Docket No.: 52-011

AR-07-0801

Southern Nuclear Operating Company  
Vogtle Early Site Permit Application  
Response to Requests for Additional Information Letter No. 6 Involving Geology/Seismology

**Response to March 15, 2007 RAI Letter No. 6**

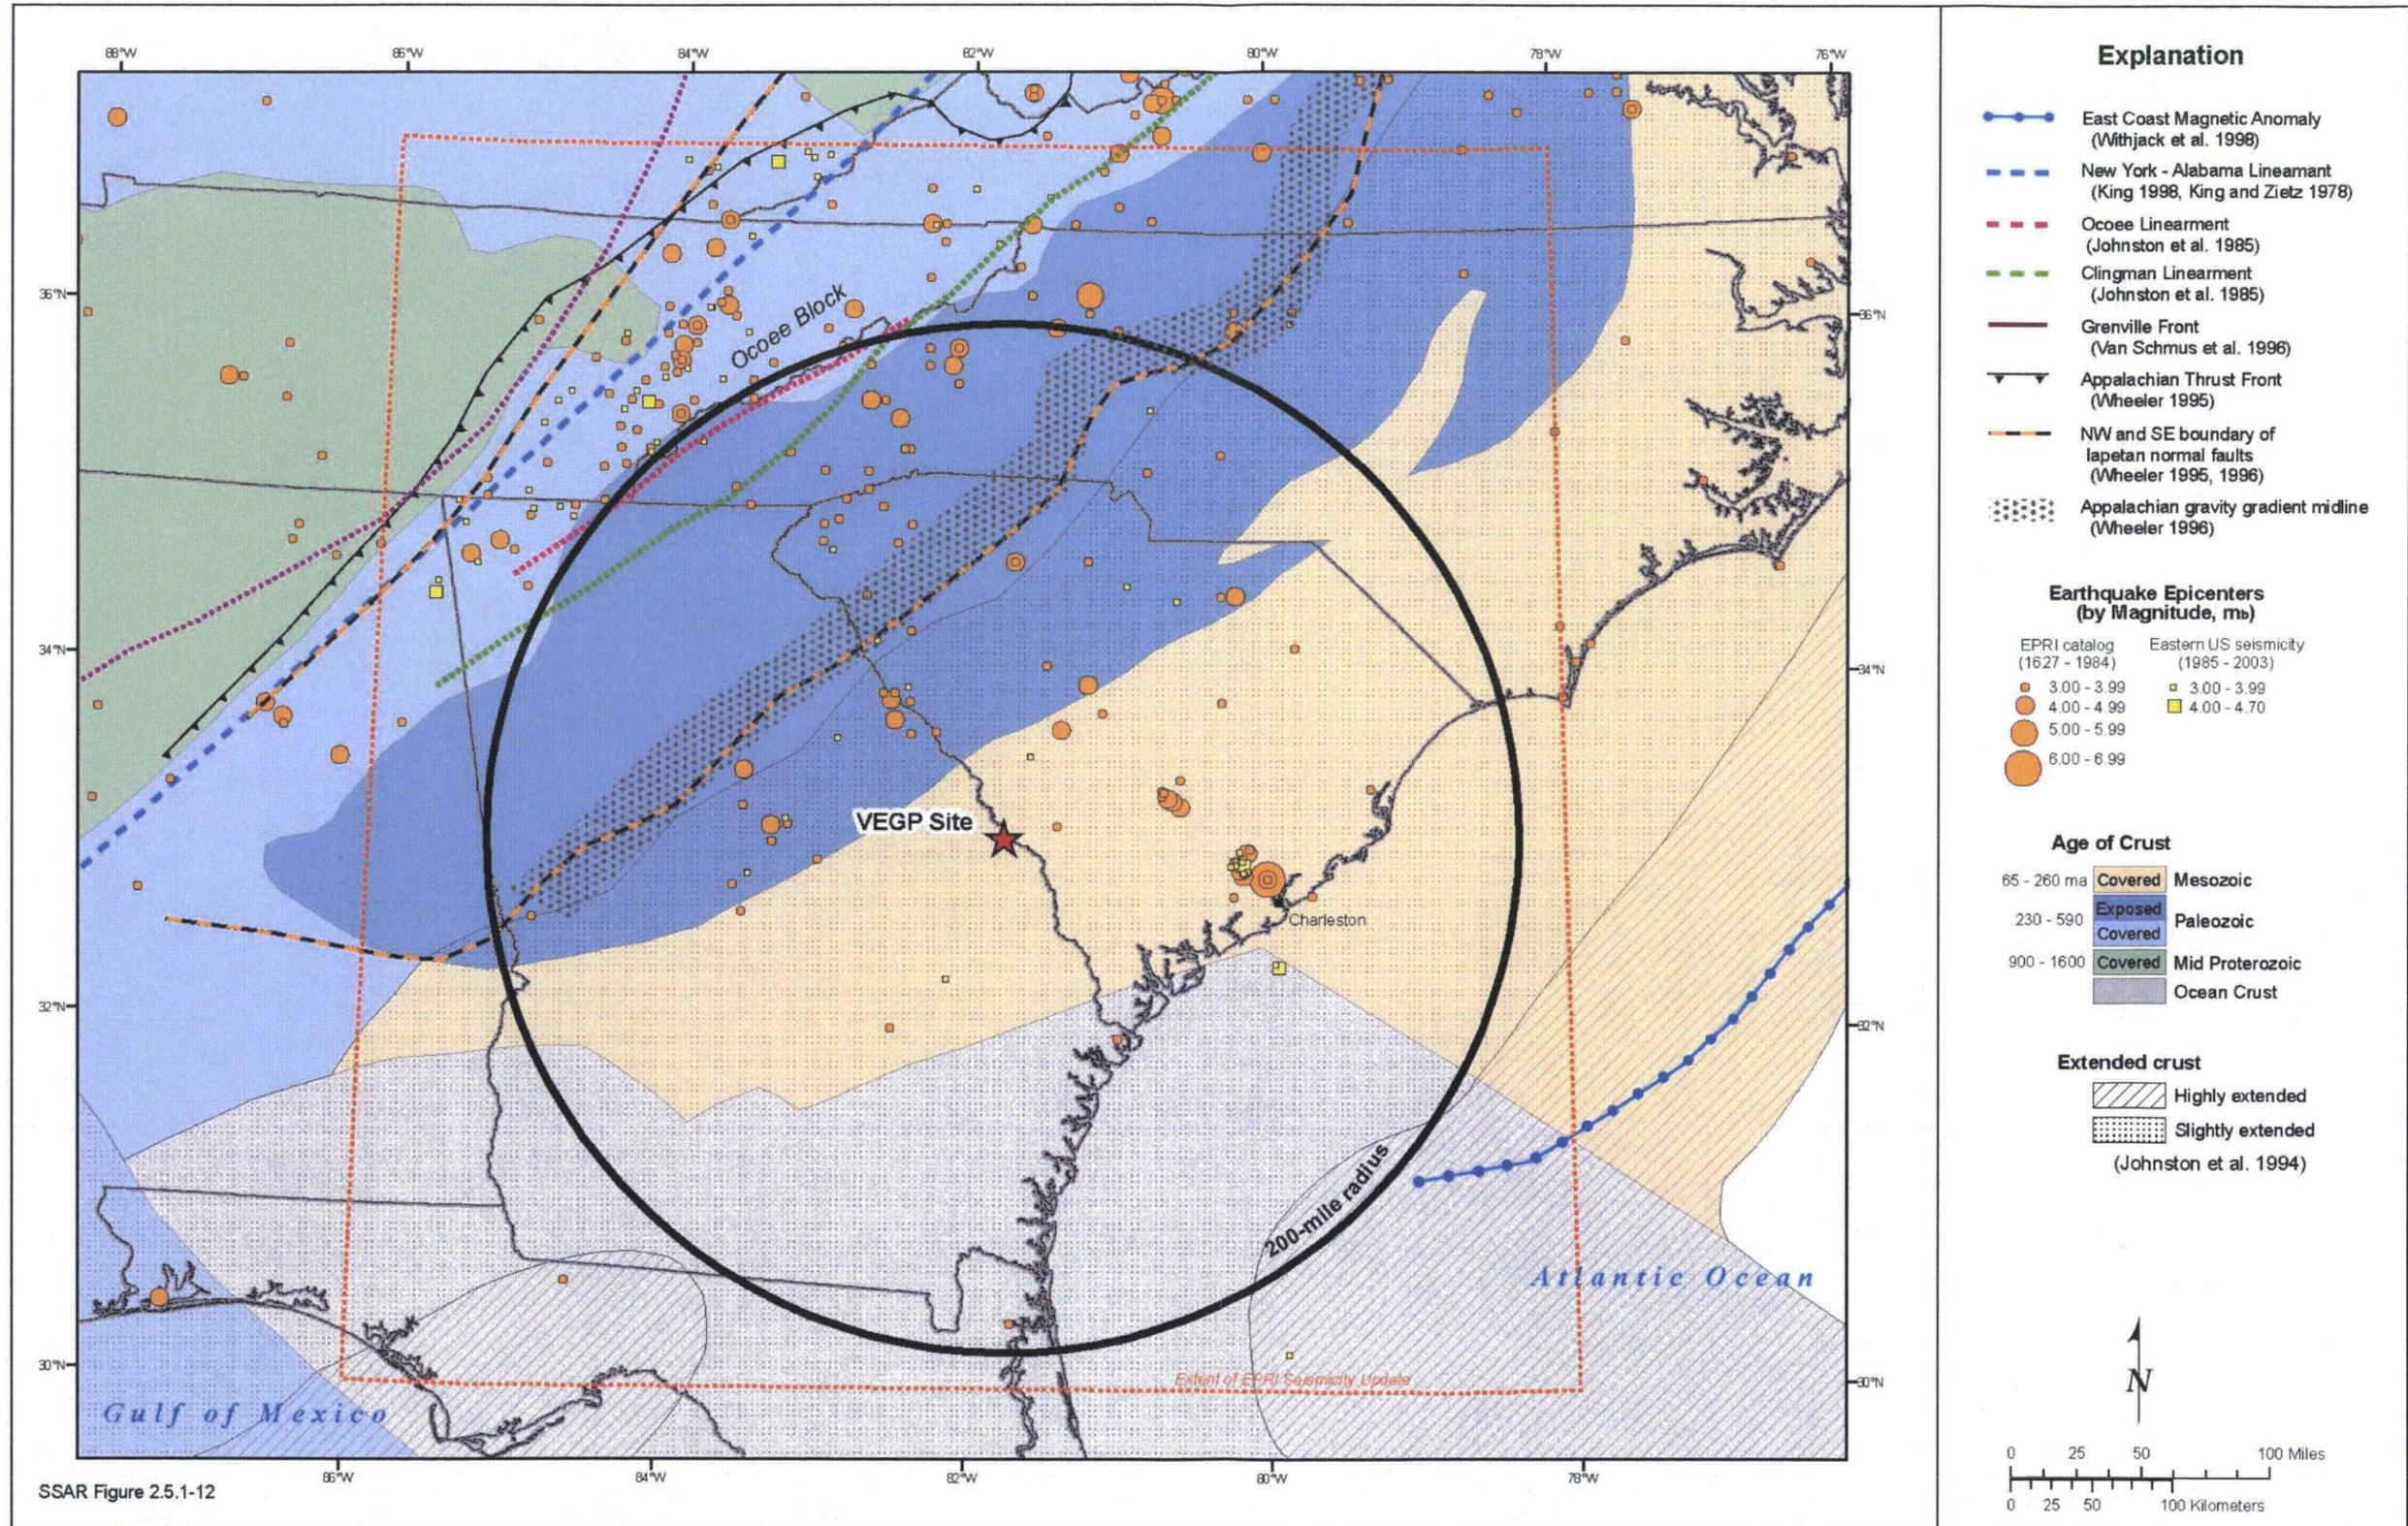
**2.5.1-7 In Section 2.5.1.1.4.3, the Grenville Front is not described under “Regional Geophysical Anomalies and Lineations”, although it is listed among the features occurring within 200 mi of the VEGP site and shown in SSAR Figure 2.5.1-12.**

**Please describe this regional feature, including whether or not is considered to be a potential seismic source, and provide a basis for the conclusion.**

**2.5.1-8** Of the six regional geophysical anomalies and lineaments listed in SSAR Section 2.5.1.1.4.3, information is presented to explain why the East Coast and Blake Spur magnetic anomalies are not considered as potential seismic sources. Discussions of the New York-Alabama, Clingman, and Ocoee lineaments do not indicate whether or not they could be potential seismic sources. Also, locations of the Clingman and Ocoee Lineaments and the Ocoee Block are not illustrated in Figure 2.5.1-12, and earthquakes interpreted by Wheeler (1996) as occurring within the Ocoee block in the “modern” tectonic setting were not quantified with regard to the age of faulting with which these earthquakes were associated. (SSAR Section 2.5.1.1.4.6 includes a discussion of the Eastern Tennessee Seismic Zone in which seismic events have occurred that are related to the Ocoee block.)

**a. Please correct Figure 2.5.1-12 to include the Clingman and Ocoee Lineaments and the Ocoee Block.**

The Grenville Front was erroneously listed under “Regional Geophysical Anomalies and Lineations” as a feature occurring within 200 mi of the VEGP site. The Grenville Front, which is described under section 2.5.1.1.4.1 (Plate Tectonic Evolution of the Appalachian Orogenic Belt at the Latitude of the Site Region), is located beyond the 200 mi site region and was not shown on SSAR Figure 2.5.1-12. The “Grenville Craton – Eastward Extent” of Ebel and Tuttle (2002) was shown on SSAR Figure 2.5.1-12, which is taken from Wheeler’s (1996) representation of the southeast boundary of the intact Iapetan margin and does not represent the Grenville Front. SSAR Figure 2.5.1-12 has been revised (as shown following this response) to eliminate any confusion by showing the Grenville Front and changing the name of the Ebel and Tuttle (2002) feature to the original name given by Wheeler (1996).

The southeast and northwest boundaries of Iapetan normal faults shown in the revised SSAR Figure 2.5.1-12 (following this response) define the extent of the Iapetan margin of the craton containing normal faults that accommodated extension during the late Proterozoic to early Paleozoic rifting of the Iapetan Ocean. Wheeler (1996) defined the southeast boundary as the southeastern limit of the intact Iapetan margin, which is nearly coincident with the Appalachian gravity gradient in the southeastern US. The Iapetan normal faults are concealed beneath Appalachian thrust sheets that overrode the margin of the craton during the Paleozoic. A few of these Iapetan faults are thought to be reactivated and responsible for producing earthquakes in areas such as eastern Tennessee; Giles County, Virginia; and Charlevoix, Quebec (Bollinger and Wheeler 1988, Wheeler 1996).

The southeast margin of the Iapetan normal faults shown on SSAR Figure 2.5.1-12 does not represent a potential seismic source since it does not represent a discrete crustal discontinuity or tectonic structure. The linear feature shown in the SSAR Figure 2.5.1-12 (following this response) represents the southeastern extent of the intact Iapetan margin (with a location uncertainty of 30 to 35 km), and therefore, the southeastern limit of potentially seismogenic Iapetan faults (Wheeler 1996).

The Clingman and Ocoee lineaments and the Ocoee block are discussed in the text, but are not labeled on SSAR Figure 2.5.1-12. This will be corrected in the next revision of the ESP application. The revised SSAR Figure 2.5.1-12 is as shown in RAI 2.5.1-7.

RAI Figure 2.5.1-11

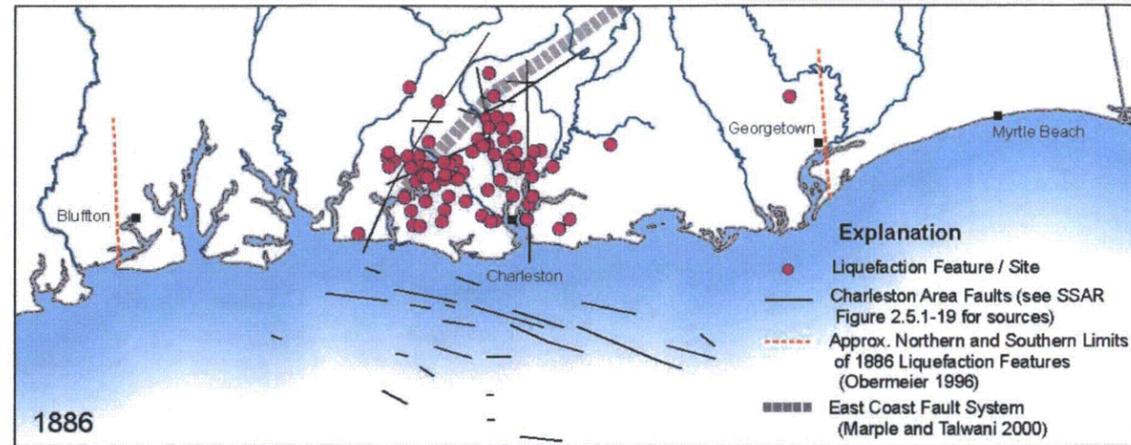
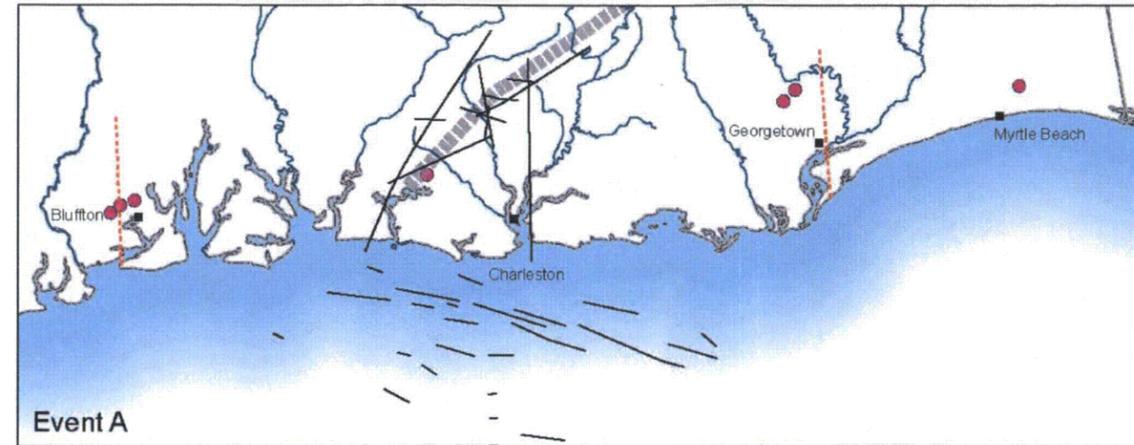
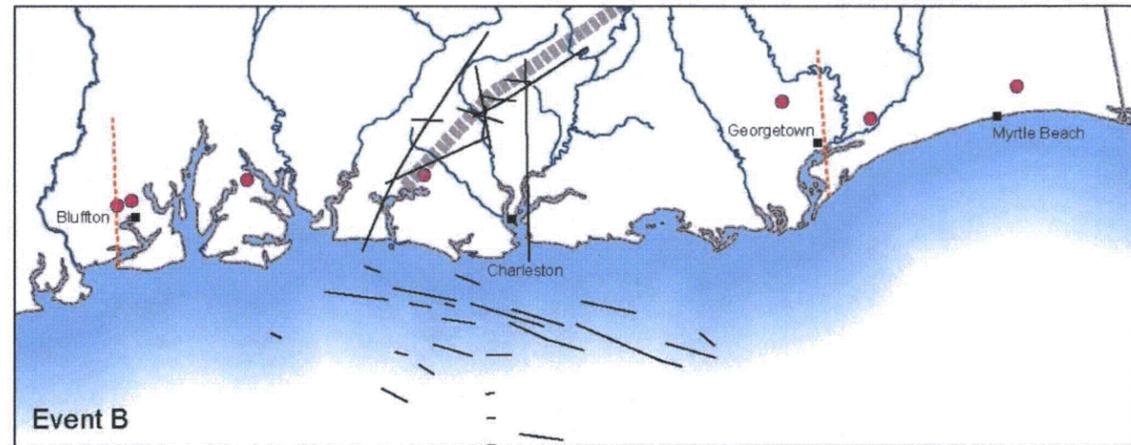
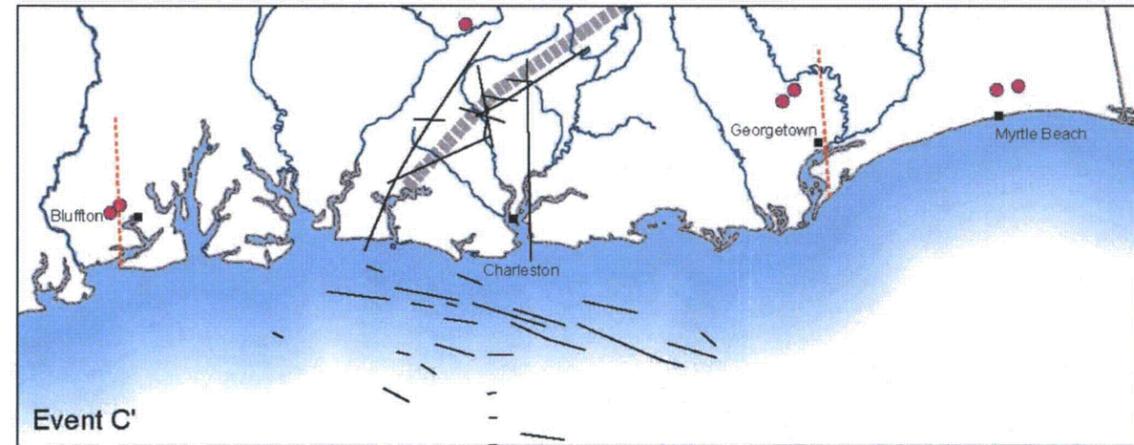
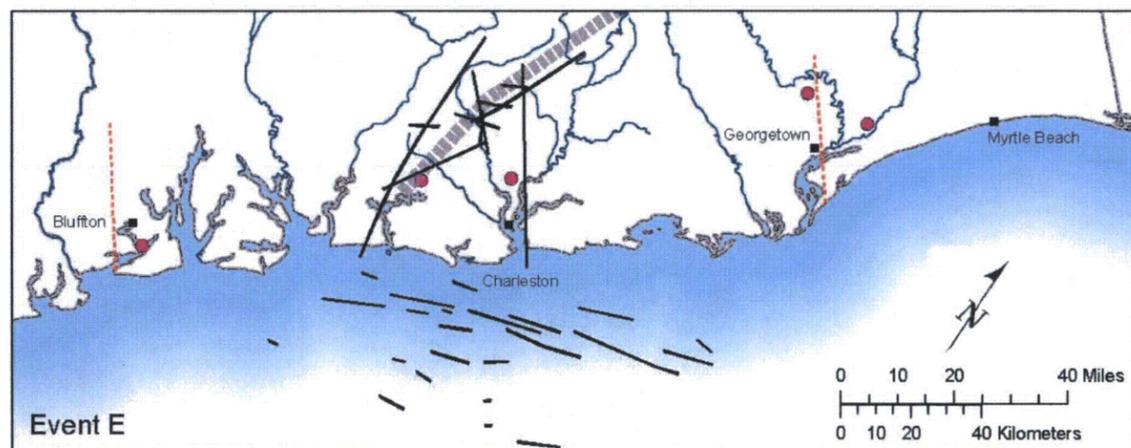
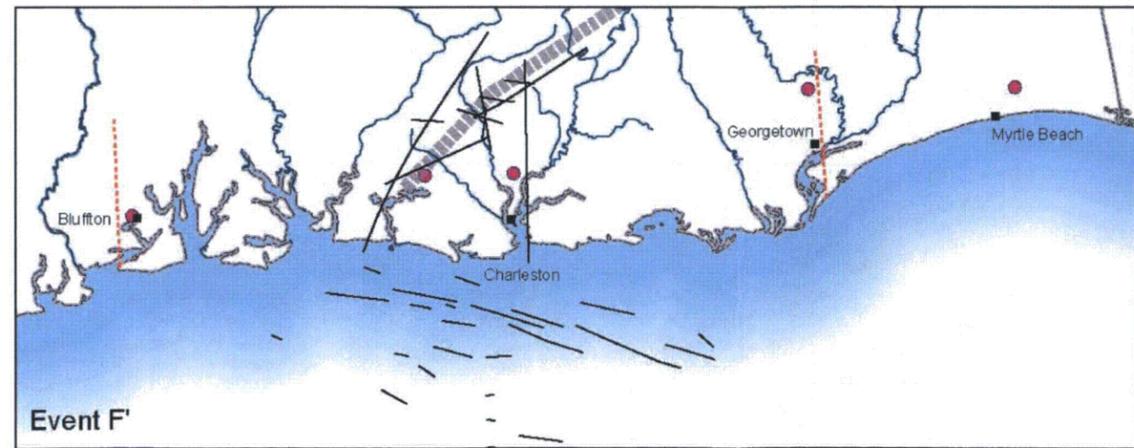
**2.5.1-11** Figure 2.5.1-19 of SSAR Section 2.5.1.1.4.4 is important for illustrating what is known or inferred about which liquefaction features may be related to the 1886 Charleston earthquake as opposed to other past earthquake events, and for correlating geographic proximity of individual liquefaction features with each other and with proposed sources.

**Please provide new figures that clearly distinguish the liquefaction features related to the 1886 Charleston earthquake from each of the proposed paleoliquefaction events A,B,C',E,F' (C' to include C and D events from Talwani and Schaeffer, 2001 and F' to include F and G events, also from Talwani and Schaeffer, 2001). These figures should outline the areal extent of the features associated with each event, how they correlate with areal coverage of 1886 features, and their proximity to the regional tectonic structures shown in SSAR Figure 2.5.1-19.**

RAI Figure 2.5.1-11 following this response depicts the geographic distributions of liquefaction features associated with the 1886 earthquakes and each of the proposed prehistoric Charleston seismic source earthquakes. SSAR Figure 2.5.1-19 differentiates between 1886 liquefaction features and those features that pre-date 1886, but does not show the geographic distribution of liquefaction sites for each event in the prehistoric record.

RAI Figure 2.5.1-11 shows the liquefaction features associated with the 1886 Charleston earthquake, as well as the liquefaction sites associated with each of the proposed paleoliquefaction events (Events A, B, C', E, and F'). An important observation from RAI Figure 2.5.1-11 is that the spatial distributions of paleoliquefaction sites for Events A, B, C', E, and F' closely approximate the spatial distribution of 1886 liquefaction features.

RAI Figure 2.5.2-11, Liquefaction Sites for Events C', C, and D

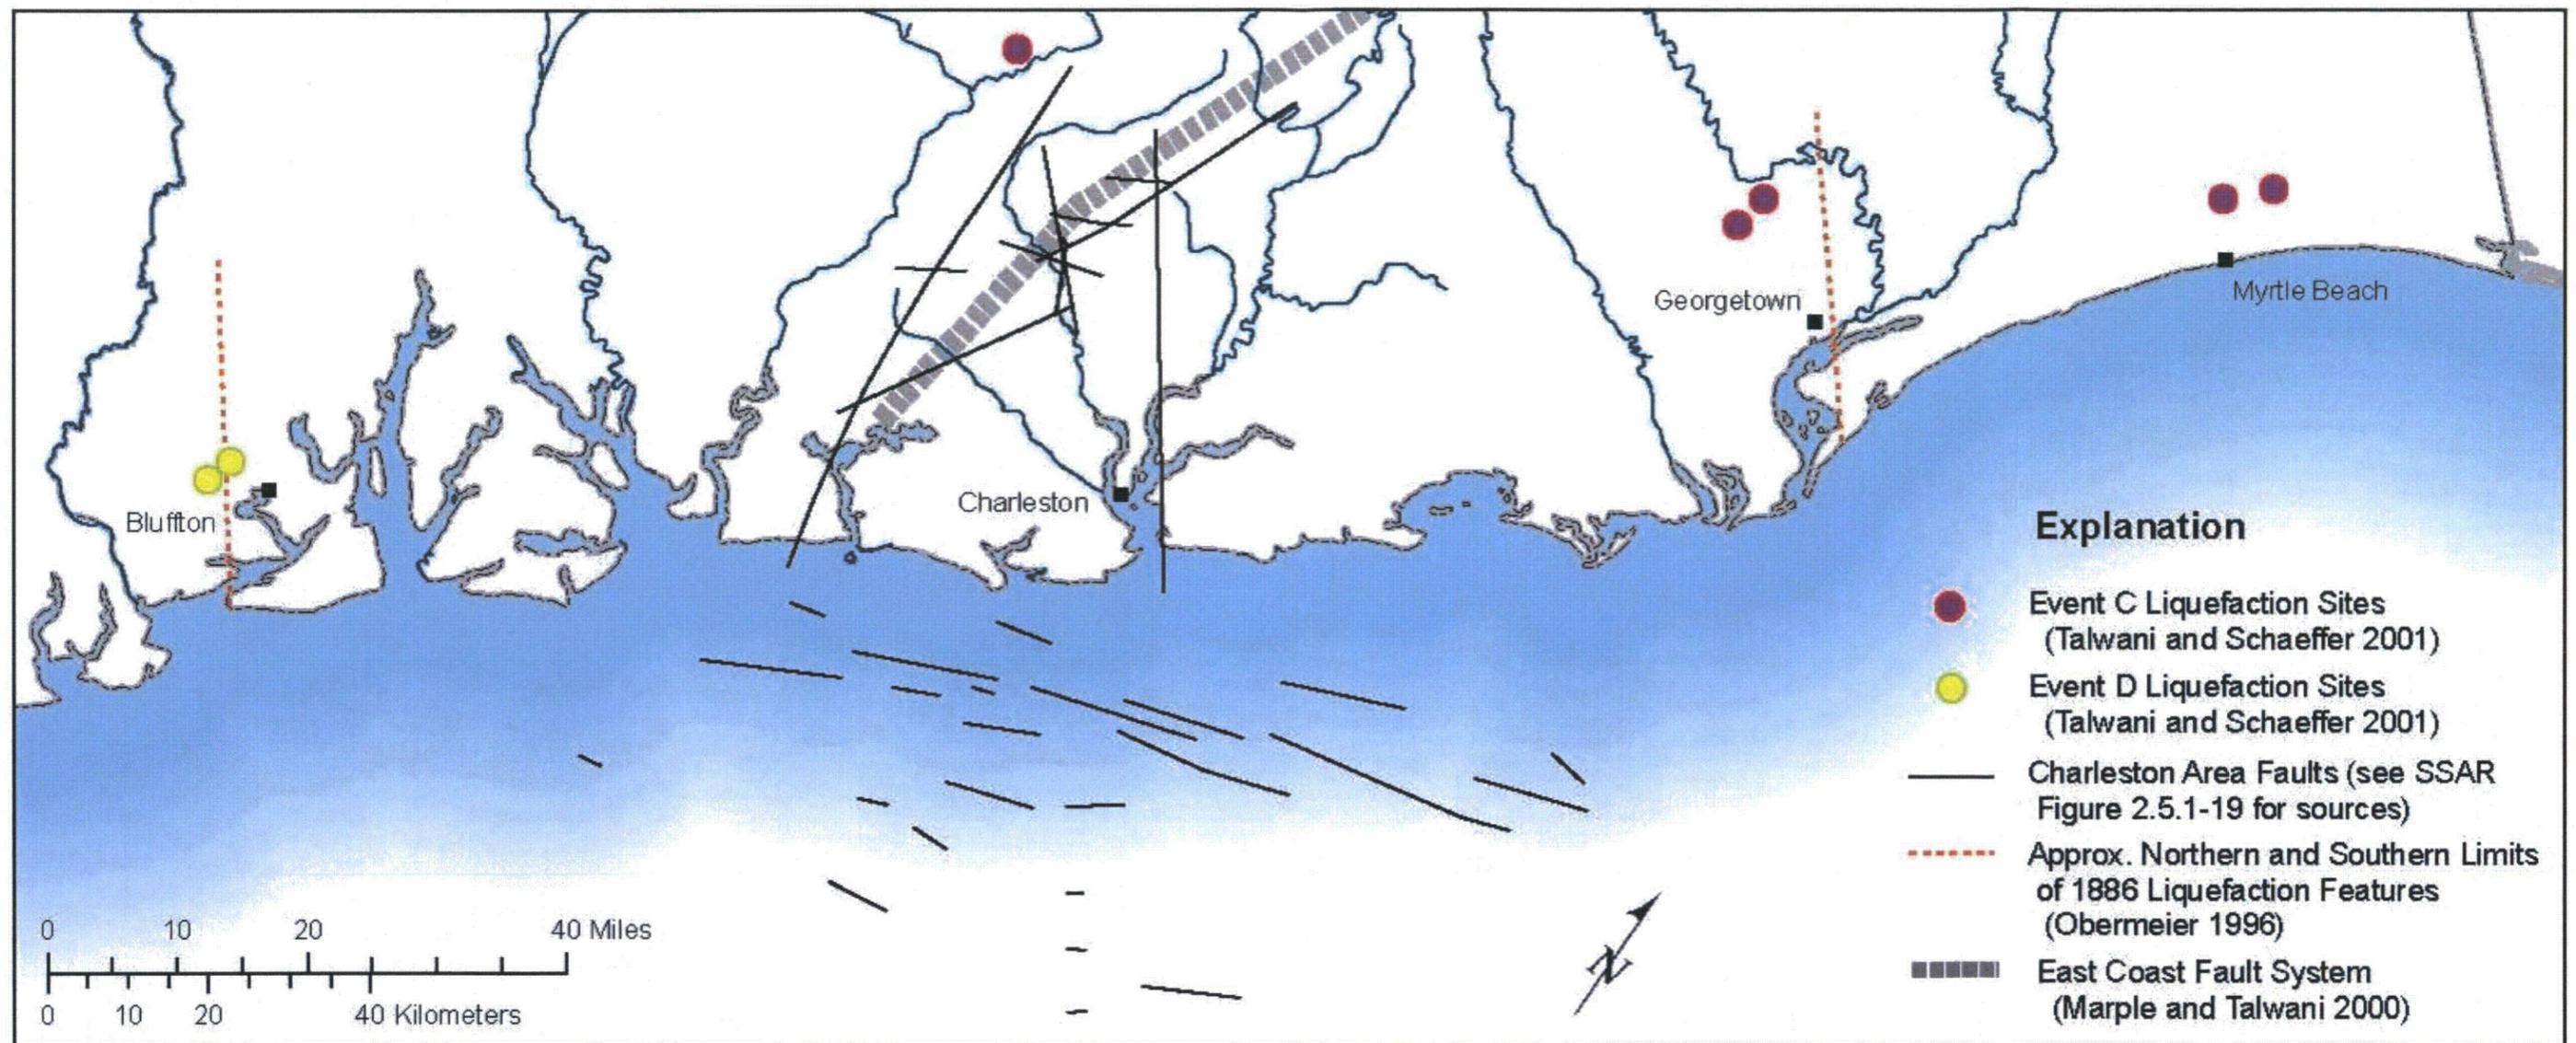
**Please provide any information on liquefaction features, geographically located between these two areas, that have similar radiocarbon ages which supports your characterization of these events as a single large event rather than two separate events. Provide justification that there is enough paleoliquefaction data to support a single large event C' from a single source.**

The geographic distributions of paleoliquefaction sites and the 1-sigma age estimates for Events C and D suggest these events may be separate, moderate magnitude (~M 6) events (Talwani and Schaeffer 2001). The liquefaction sites for Events C and D are localized and show no spatial overlap, and therefore do not provide definitive geographic evidence for combining these events into a single, large Event C' (see RAI Figure 2.5.2-11 following this response). However, Talwani and Schaeffer (2001) also interpret another scenario in which Events C and D may be the same event (Event C'). Using 2-sigma age ranges for radiocarbon dates performed in the VEGP ESP study, Events C and D are indistinguishable based on timing alone.

The decision to include a single, large magnitude Event C' (instead of smaller magnitude, localized Events C and D) into the updated Charleston seismic source model used in the VEGP ESP application is based on three reasons:
